# Bid Addendum

## Addendum No.: 3

Project Name: Harnett Street Stormwater Improvements

1. Requests for Information
  - a. See attached document
2. Changes to the Project Manual
  - a. Bid form
3. Changes to the Construction Documents
  - a. C51, C52, C53, C54

HORIZONTAL SCALE: 1"=20'  
VERTICAL SCALE: 1"=4'

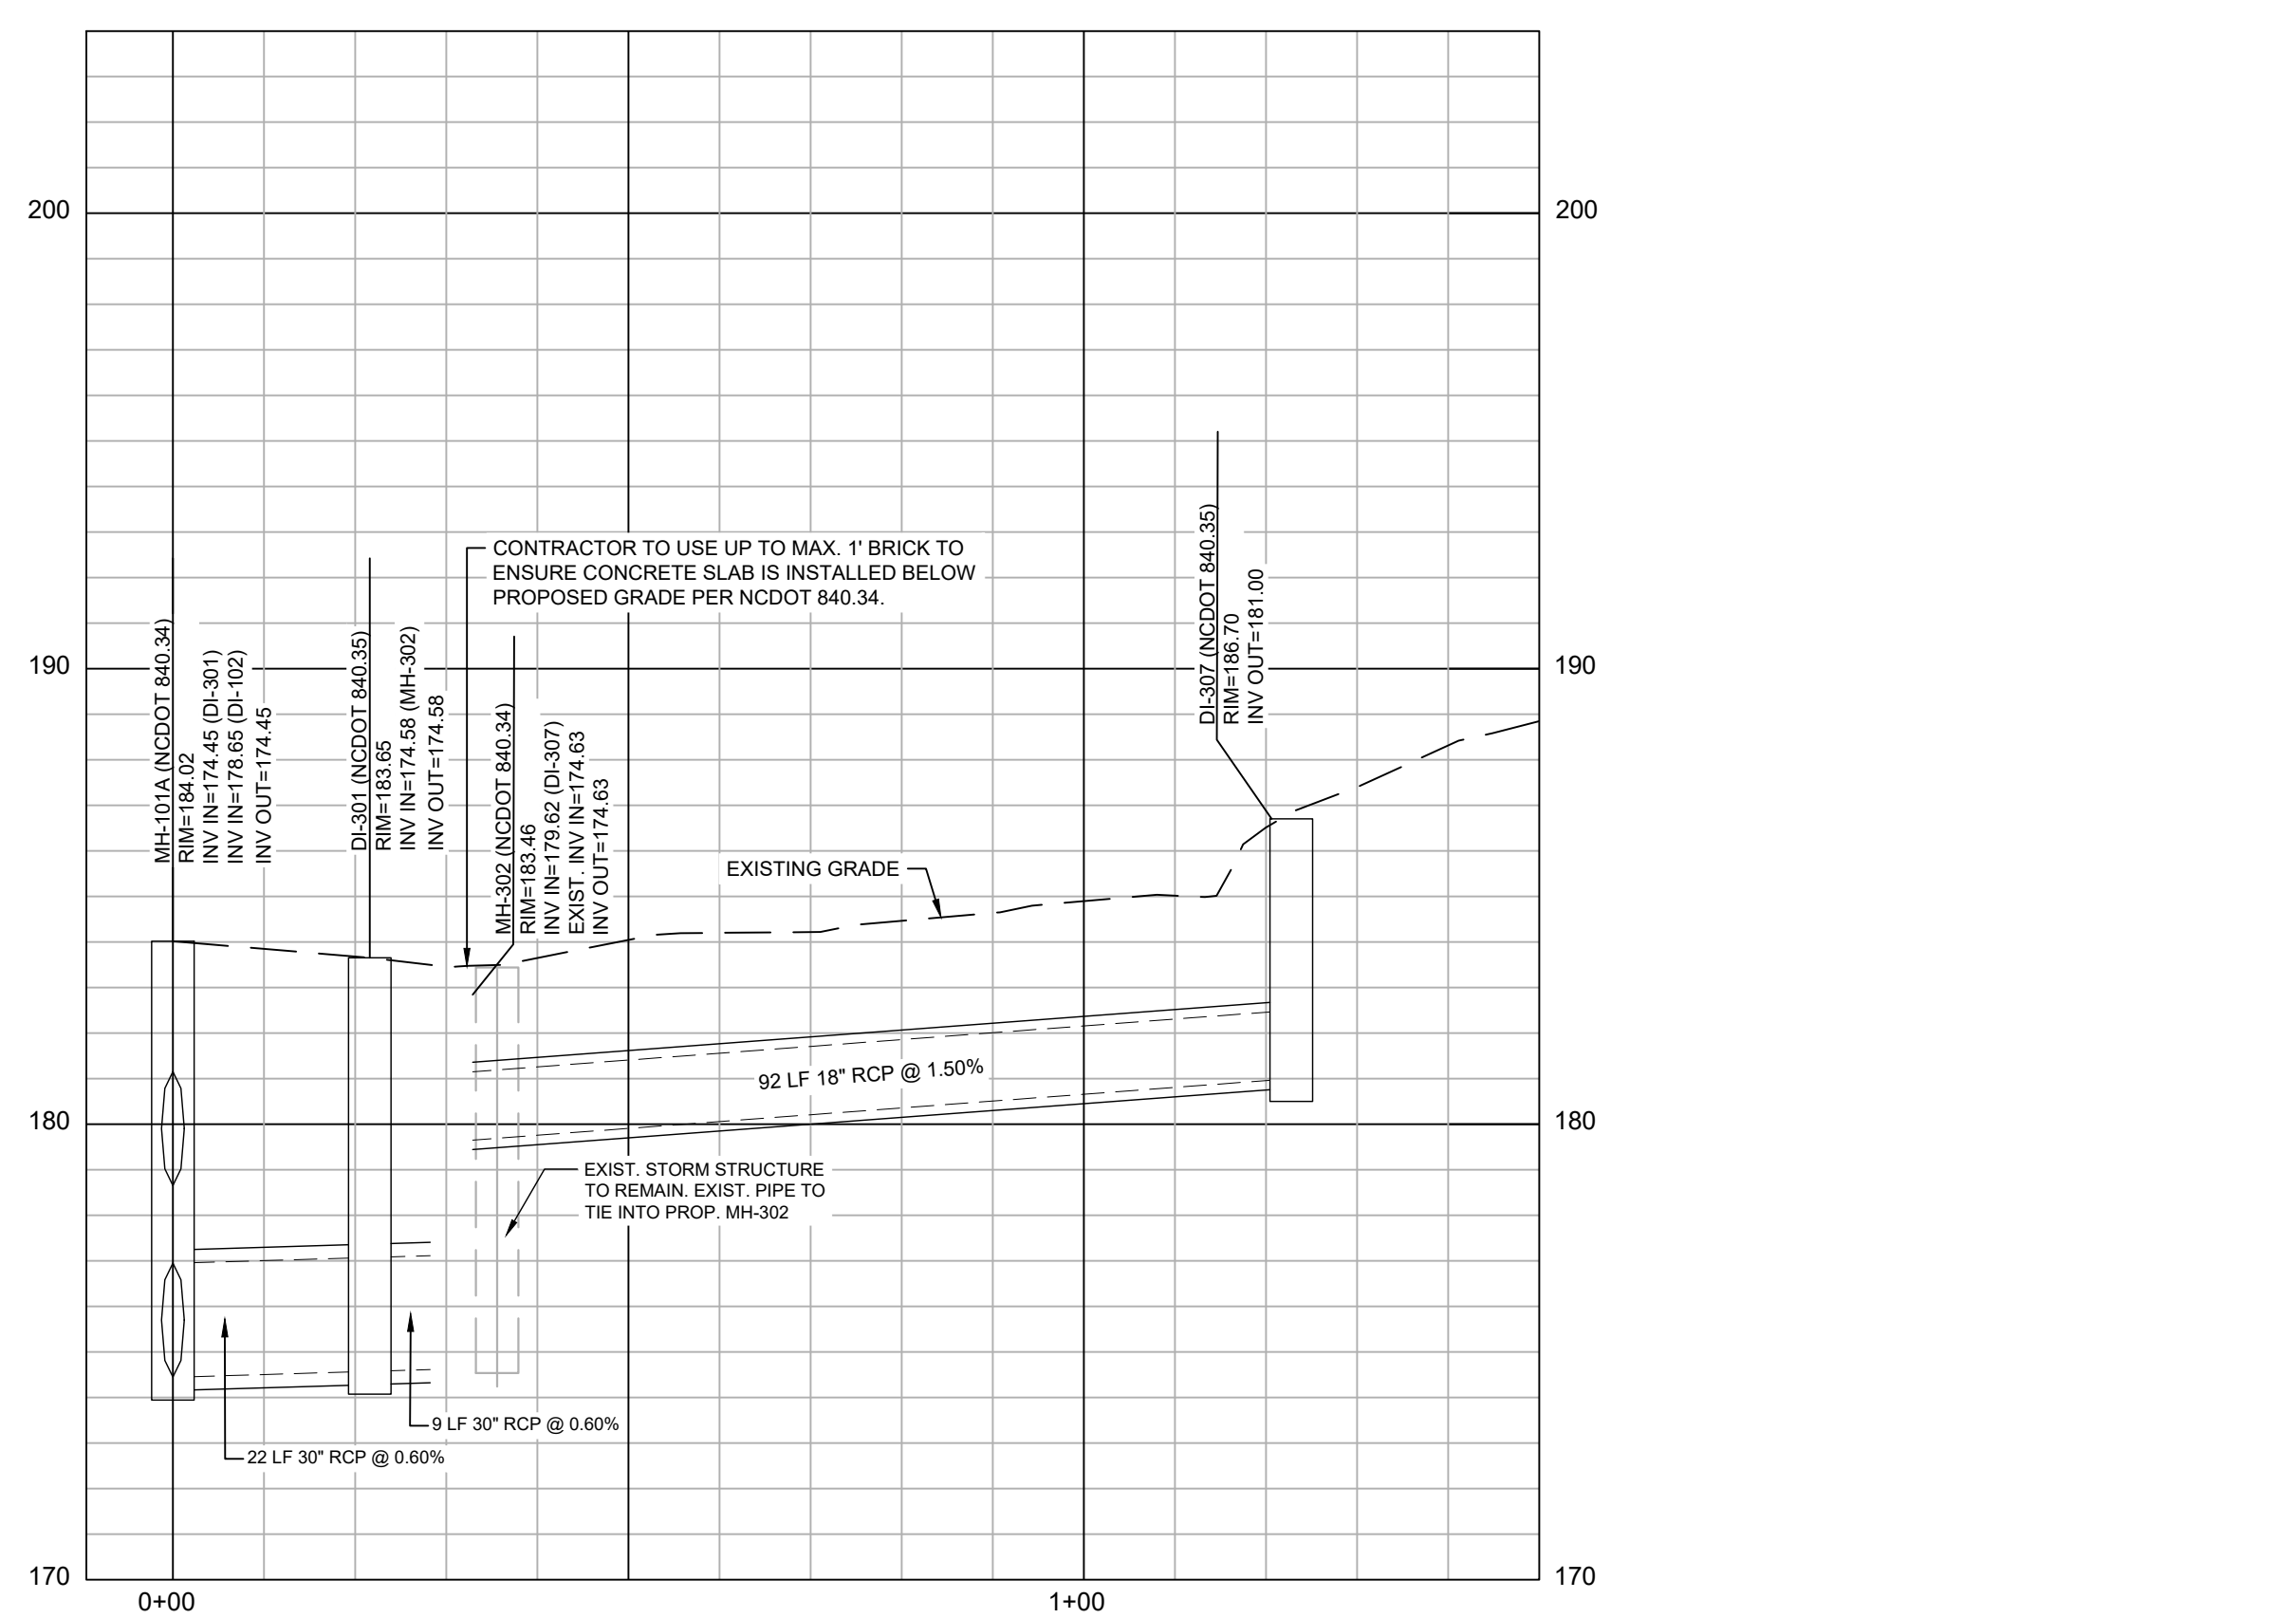
8. Are there waterline plans that correspond to the waterline bid items on the McAdams bid form? Only 6" Waterline relocations are shown on the plans.

**Engineer Response: There are 6" waterlines that are being relocated horizontally, shown in plan view in the construction documents (Sheets C51, C52, C54). There are also vertical relocations due to unknown watermain depths, which account for the additional 4" and 8" waterline bid items (A-41, A-43). These horizontal and vertical relocations are reflected in profile view in the construction documents (see attached Sheets C51, C52, C53, C54).**
